ACNW'S INTEGRATED STRATEGY TO EVALUATE THE STAFF'S LICENSING CAPABILITY AND SUFFICIENCY REVIEW

**Dr. B. John Garrick
Chairman, ACNW
March 22, 2001**

ACNW'S VERTICAL SLICE REVIEW

Example of Vertical Slice Review – Saturated Zone KTI

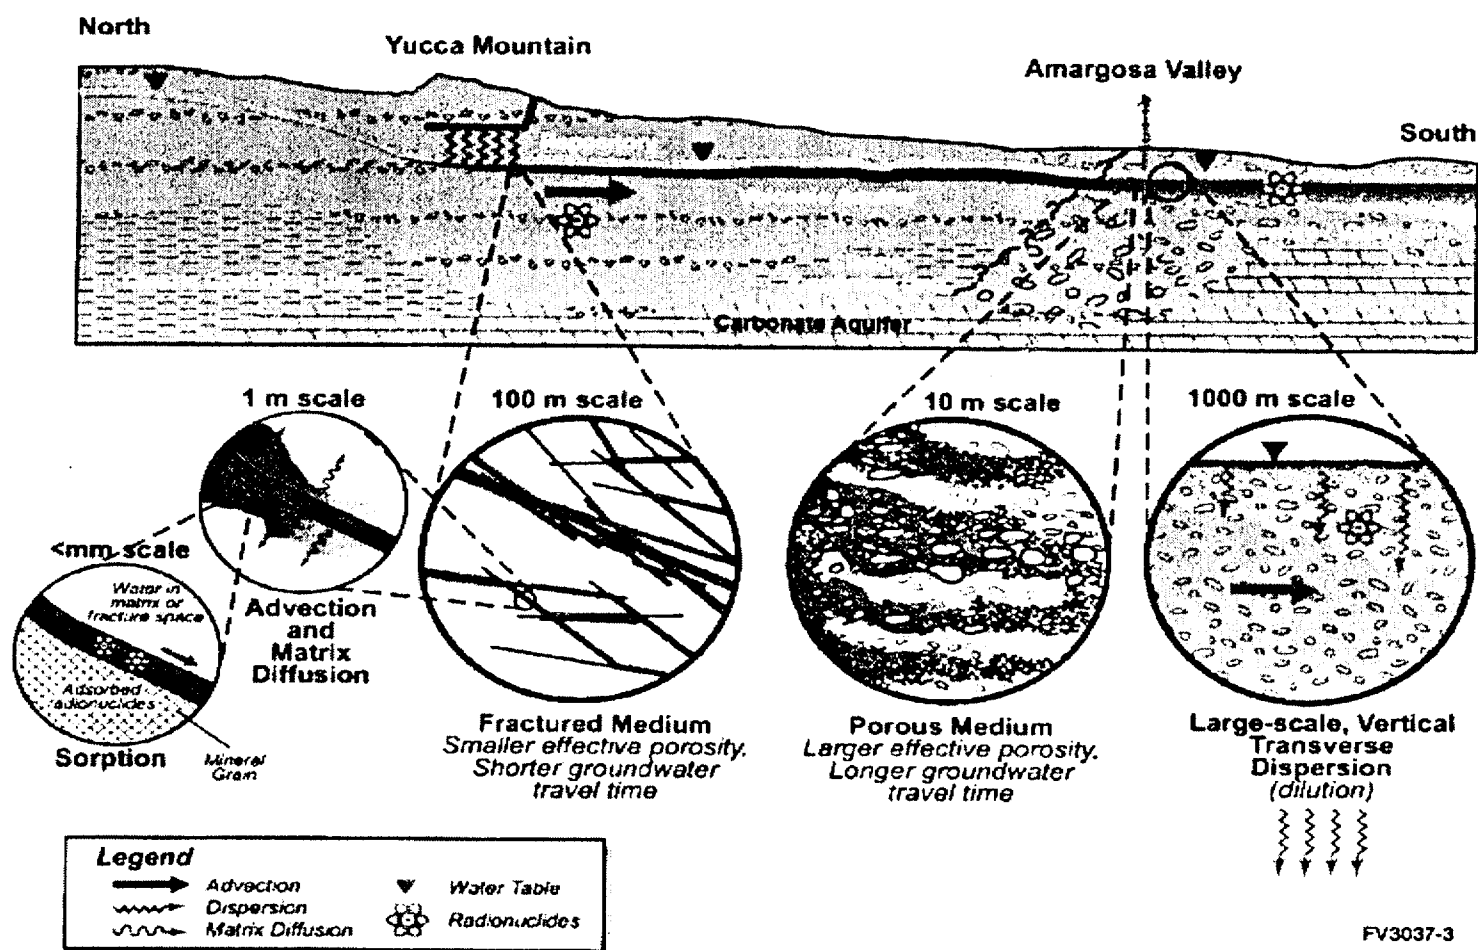
- **ACNW Approach:**
 - **Is the staff's basis for closed-pending status transparent?**
 - **Is NRC's approach RIPB?**

Example of Vertical Slice Review – Saturated Zone KTI

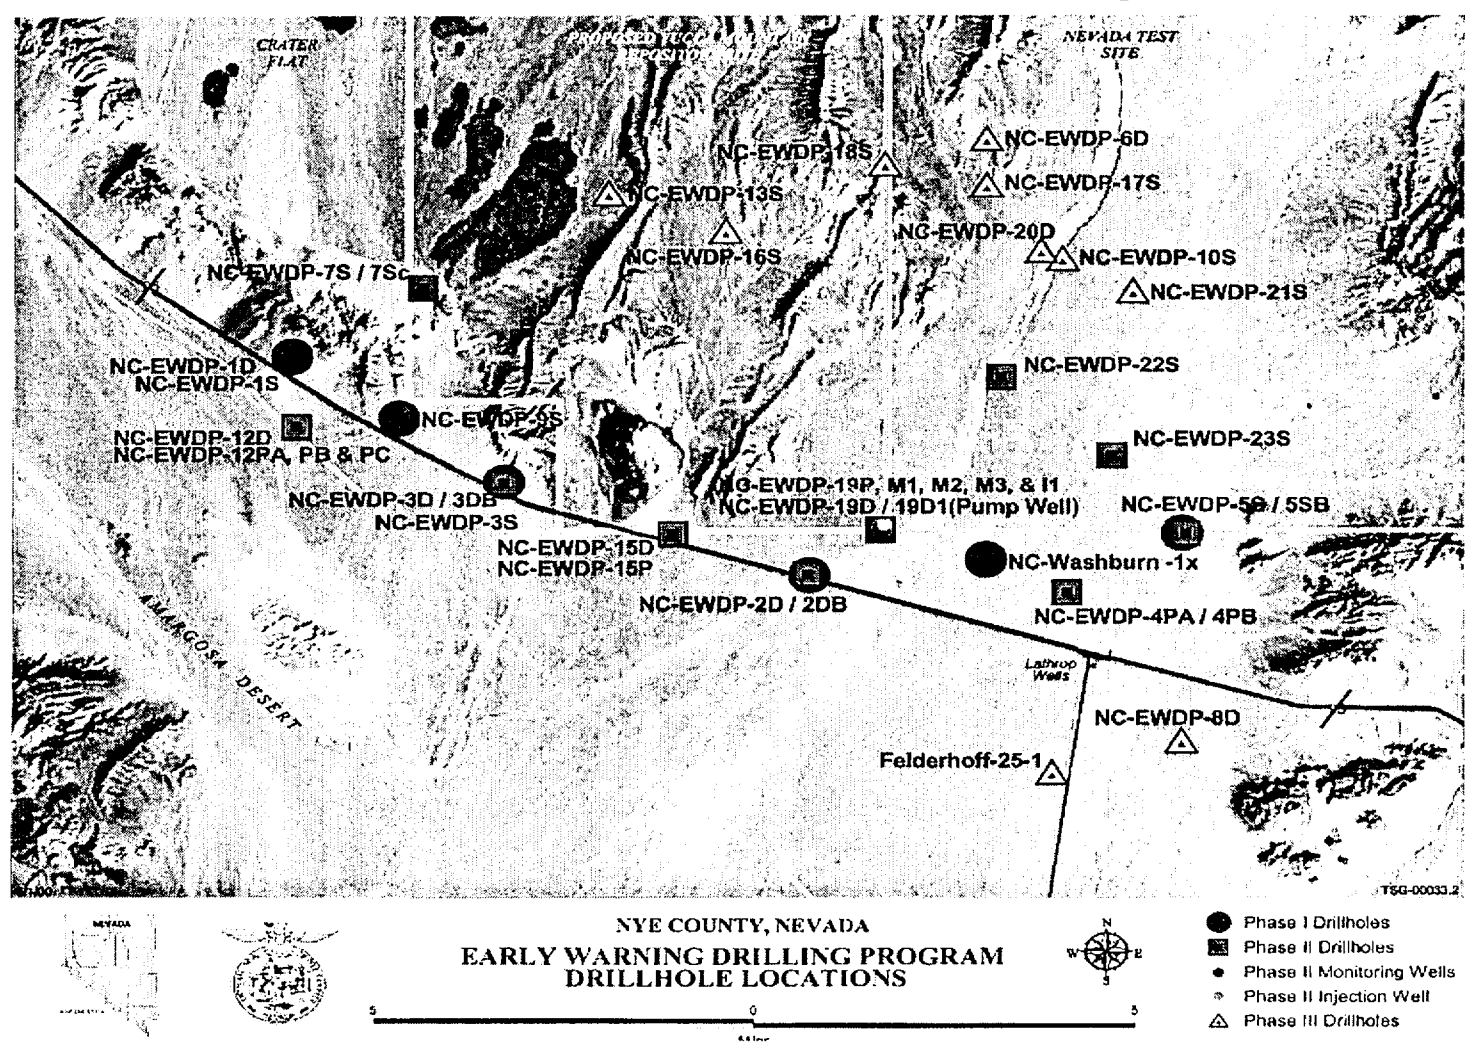
Some NRC staff concerns about SZ flow:

- Anisotropy?
- Flow paths in alluvium?
- Alternative conceptual models?

- Some NRC staff requests:**
- Detailed plan for alluvial testing
 - Justification for uncertainty of paths
